ARMENIAN CHURCH AND CULTURAL CENTER JSP17-37

Public hearing at the request of Armenian Cultural Center for Special Land Use, Preliminary Site Plan with Land bank Parking, Phasing Plan, Shared Parking Agreement, Wetland Permit, Woodland Permit, and Storm water Management plan approval. The subject property is located in section 12, on the north side of Twelve Mile Road and east of Meadowbrook Road, in residential acreage (RA) zoning district. The applicant is proposing a church and a cultural center with accessory uses such as day care center, multipurpose hall, café, religious educational rooms, Armenian genocide memorial and recreational facility. The applicant is proposing to construct in three phases. The project area comprises of four parcels is approximately 19.30 acres. A Special Land Use Permit is required to permit Places of Worship and a daycare in residential districts.

PLANNING REVIEW

Figure 1. City of Novi Regulated Wetland & Woodland GIS Coverage Map (approximate project boundary shown in red). Regulated Woodland areas are shown in green and regulated Wetland areas are shown in blue.

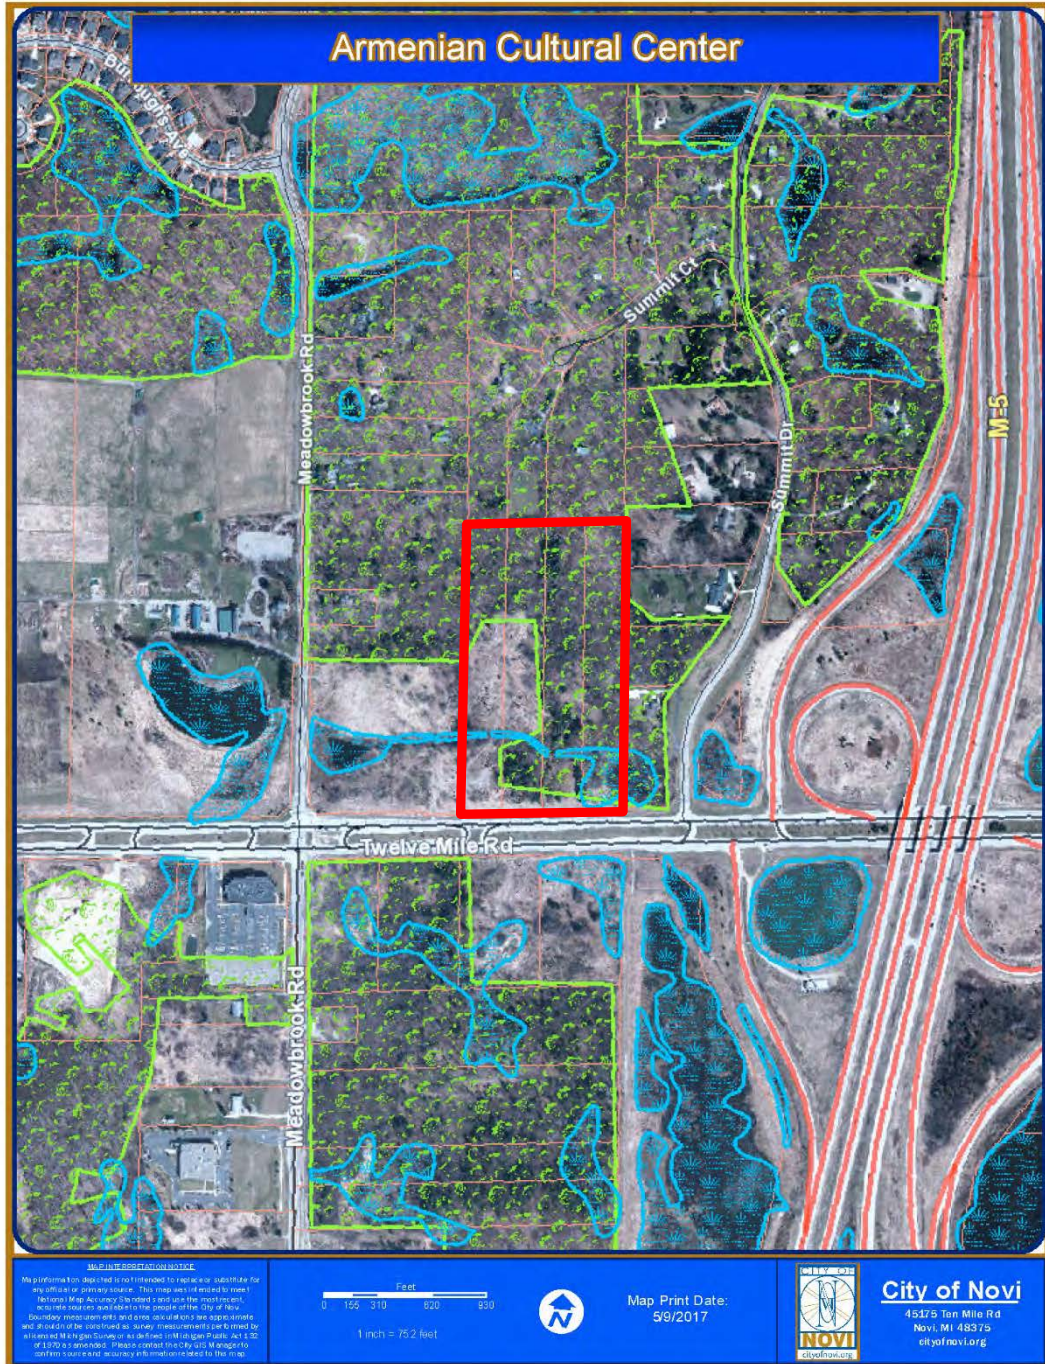
Based on our review of the Plan, Novi aerial photos, Novi GIS, and the City of Novi Official Wetlands and Woodlands Maps (see Figure 1), it appears as if this proposed project site contains Regulated Wetlands as well as Regulated Woodlands. The site appears to contain disturbed open space, a section of stream (i.e., the Townline Drain) which is tributary to the Walled Lake Branch of the Rouge River and associated wetland, and a significant amount of area that is mapped as City of Novi Regulated Woodland. The Townline Drain is a County Drain. The site is bounded by single-family residential development to the north and east, the future Beacon Hill development to the west, and Twelve Mile Road to the south. A tree survey and inventory has been completed for the site.

Figure 2. Wetland Delineation Map (map source: King & MacGregor Environmental, Inc.)

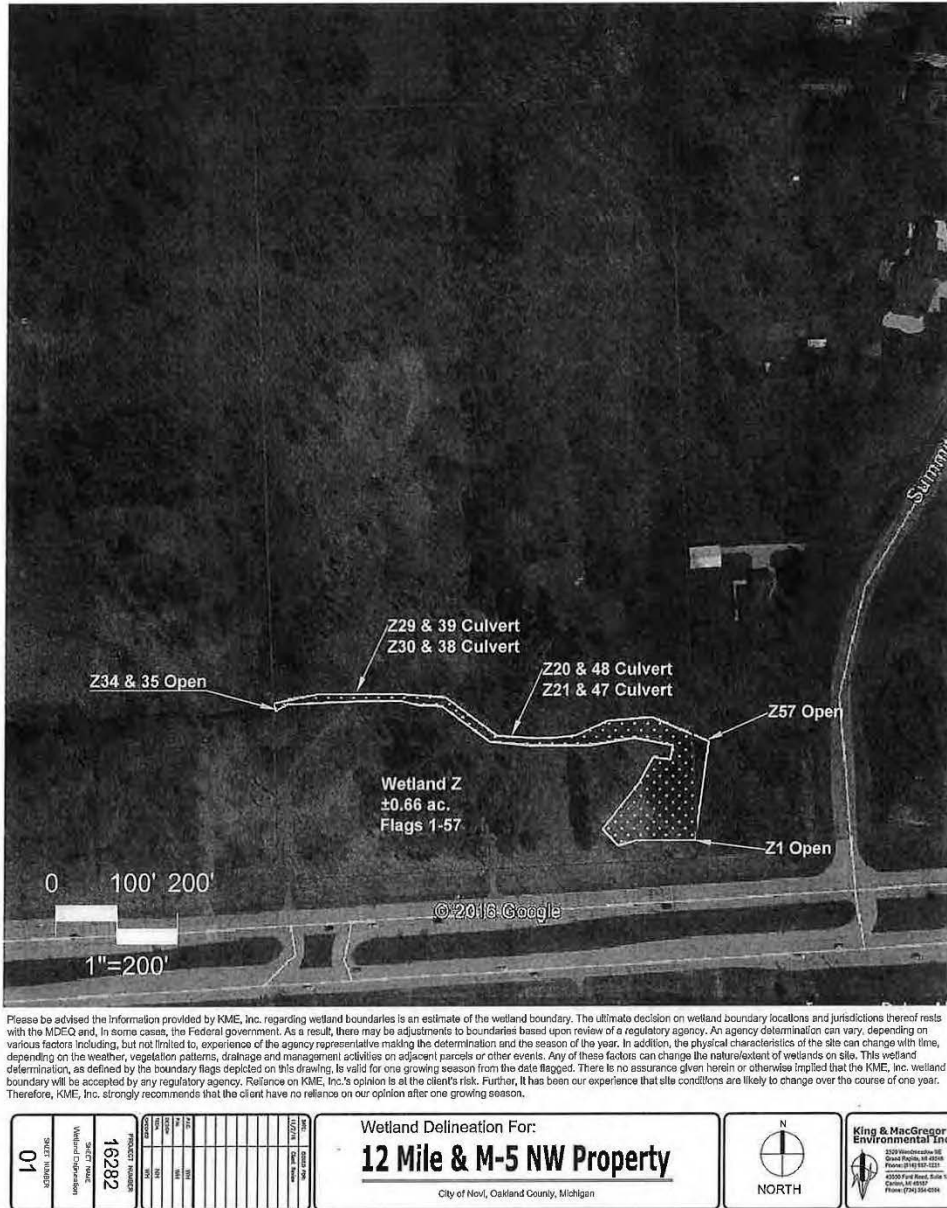
ECT has reviewed the City of Novi Official Wetland and Woodlands Map and completed an onsite wetland verification on September 5, 2017. As noted above, the Townline Drain is located along the southern section of the project site and flows from west to east. There are surveyed wetlands along either side of the existing drain totaling approximately 0.66-acre in size (see Figure 2, Wetland Delineation Map, attached). The wetland areas contain emergent, scrub-shrub, and forested type wetland vegetation. The areas of emergent wetlands are most commonly characterized by dense stands of reed canary grass with smaller areas of cattail and rush species. The areas of forested wetland include some small areas of open water containing silver maple (*Acer saccharinum*), American elm (*Ulmus americana*), ash (*Fraxinus spp.*), and several other tree species. The wetland boundaries appear to be accurately flagged in the field and displayed on the Plan.

LAND BANKED DIMENSION SITE PLAN
ARMENIAN CHURCH AND CULTURAL CENTER
SECTION 12, CITY OF HOWLAND, OHIO COUNTY, MICHIGAN

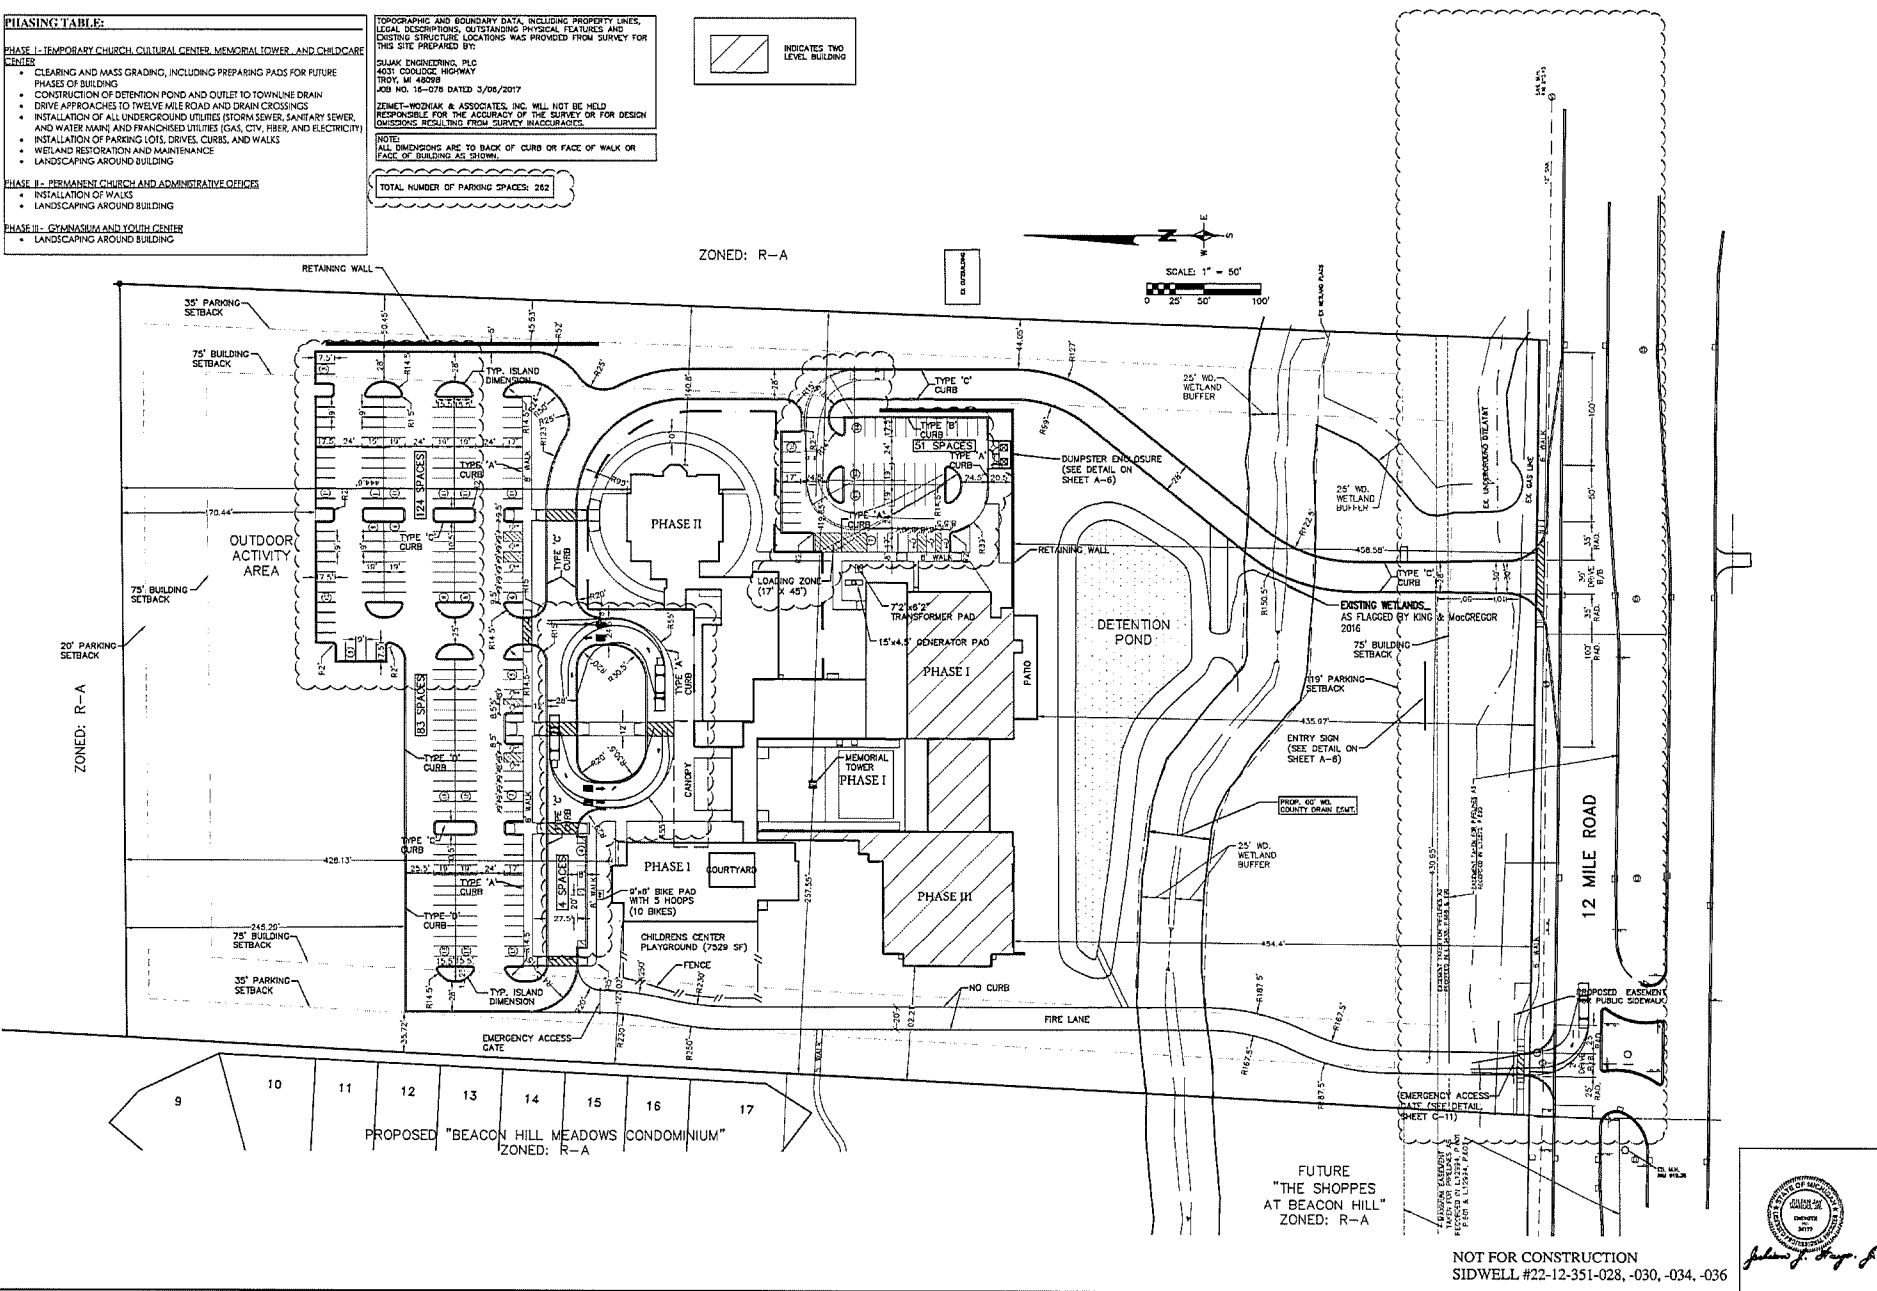
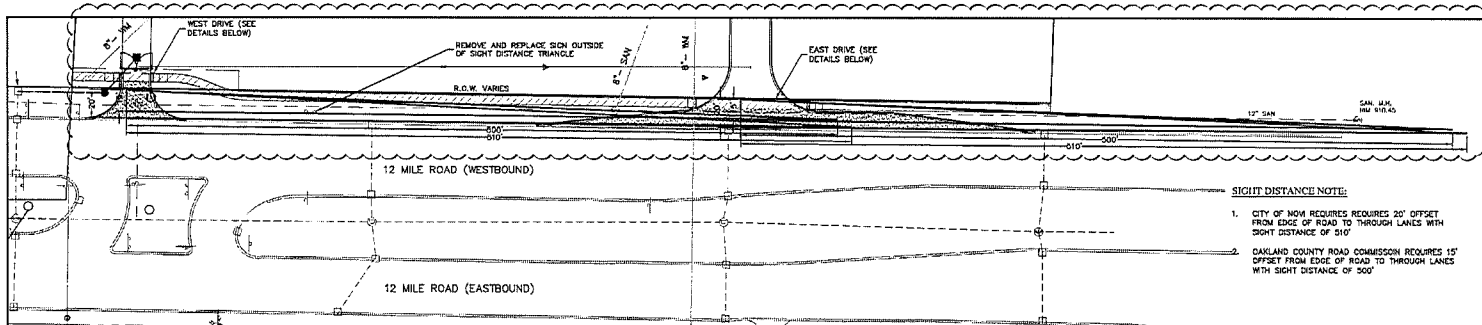
15. Retaining walls exceeding 4 feet in height require separate permit from the Building Division of the Community Development department.
16. Clarify the parking dimensions on the Land Banked parking site plan sheet C1.1. Standard parking space dimensions are 19 feet in length, or 17 feet in length with a 4-inch curb height and 2-foot overhang area.

- c. The net number of landbanked spaces has been corrected to 43 spaces, which is below the 25% of the required 262 parking spaces. The tabulation of required and landbanked can be viewed on the cover sheet. See Sheets C-1.0 and C-1.1 for plan view and dimensions of parking layout.

- d. The northwest proposed parking row length has been increased to 19' on Sheet C-1.1 to comply with City Standards upon the construction of the banked parking spaces.

- e. Additional dimensions have been added to the landbanked parking spaces on Sheet C-1.1 for further clarification.
- f. The layout of the four parallel parking spaces has been updated to meet City standards. See Sheets C-1.0 and C-1.1 for updated dimensions and layout.

EAST DRIVEWAY DIMENSION PLAN
SCALE: 1" = 10'

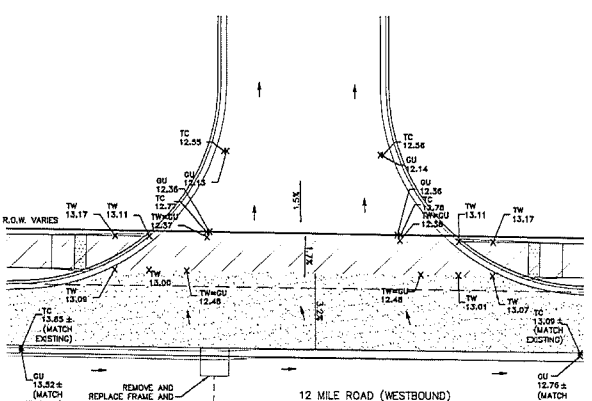
- The driveway dimension for width is below the City standard of 30 feet; however, the proposed width of 28 feet is within an allowable range. Because the standard dimension for driveway width was not used, the applicant should indicate a cause for using 28 feet as opposed to 30 feet or update the plans to include a 30 foot wide driveway. Please reference Figure IX.1 in the City’s Code of Ordinances for further clarification.

- The driveway turning radii are above the City standard of 20 feet for a driveway; however, the proposed turning radii are within an allowable range. Because the standard dimension for driveway turning radii was not used, the applicant should indicate a cause for using 35 feet as opposed to 20 feet or update the plans to include 20 foot turning radii at the driveway. Please reference Figure IX.1 in the City’s Code of Ordinances for further clarification.

- Per SEMCOG traffic count data, the Average Annual Daily Traffic (AADT) of Twelve Mile Road east of Meadowbrook Road is 15,140 vehicles. Based on the trip generation estimate letter, the peak hour right turn volume in to the development is 46 vehicles. Therefore, a right turn taper is required at the driveway on Twelve Mile Road per Figure IX.10 of the City’s Code of Ordinances. Please reference Figure IX.11 for right turn taper standards.

1. We concur with the general comment that the site driveway entrance cannot be moved due to existing wetland and wetland buffer requirements.
2. The east driveway width dimension has been increased on the plans from the previously proposed 28' to 30' at the 12 Mile Road entrance. This width will be tapered down to 28' wide prior to the drain crossing to minimize impacts to the wetlands. See Sheets C-1.0, C-1.1, and C-4.2 for updated dimensions.

4. The proposed grade of the driveway has been reduced from 3.2% to 2.0% within the first 25' of the drive. If the slope of the drive approach is held to a maximum of 2% slope, then the resultant slopes around the radius will be less than 1%. Please see Sheet C-4.2 for updated spot grades and slopes.

5. A right turn taper has been added to the east driveway entrance layout following the RCOC "Standard Approach to Paved Roads with Warranted Passing Lane" typical. The taper follows the RCOC standards as the RCOC has jurisdiction of the 12 Mile Road R.O.W. and it is the stricter policy of the two governing entities. See Sheets C-1.0, C-1.1, and C-4.2 for updated dimensions.

BICYCLE PARKING LAYOUT DETAIL
NOT TO SCALE

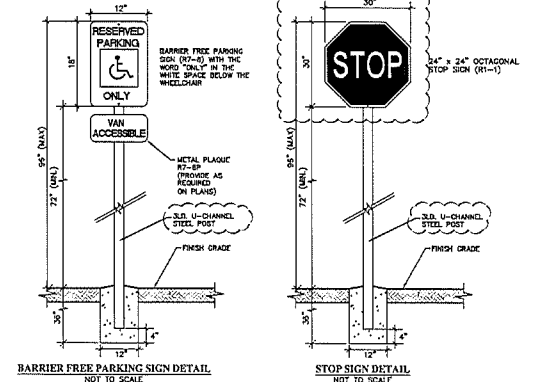
- IV. Planning Commission's approval of **Phasing plan**. The applicant is proposing to build the Church and accessory uses in three phases.
 - V. Planning deviations from Bicycle Parking and General Requirements per section 5.16 as the applicant is proposing all required 10 spaces in one location as opposed to multiple locations.

- j. The number of proposed bicycle parking spots has been added to Sheets C-1.0 and C-1.1.
- k. A bicycle parking layout detail has been added to Sheet C-11 in accordance with City of Novi standards 5.16.6
